**ADDENDUM 001
REQUEST FOR BIDS
NW ADA Restroom Renovation
Request for Bid 9-130321RW**

**Northwest District
ADA Restroom Renovation
Addendum 001
Question & Answers & Clarifications from Pre-Bid Meeting**

NORTHWEST DISTRICT
 DISTRICT COMPLEX
 RESTROOM RENOVATIONS

ADA STANDARDS

Garage-Main

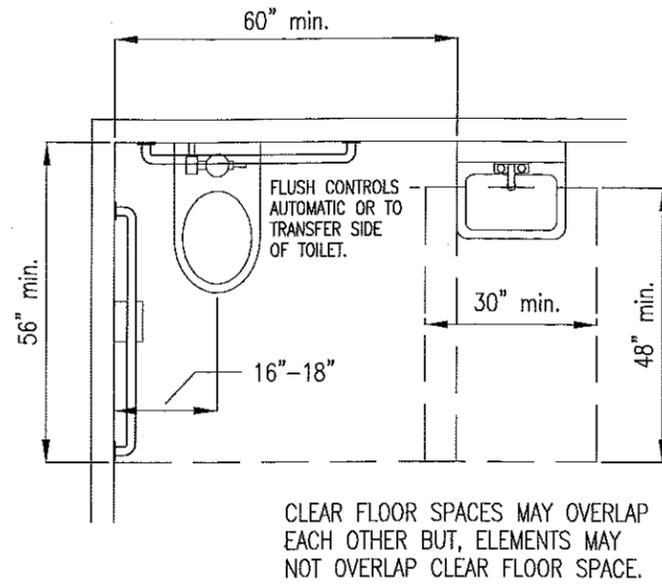
- Note there is a plumbing chase for restroom
- Ceiling – contractor shall finish ceiling with plaster or drywall mud, texture to be smooth and painted
- Eliminate the framing and sheet rocking of urinal
- Contractor to mount urinal to block wall and reroute plumbing in chase
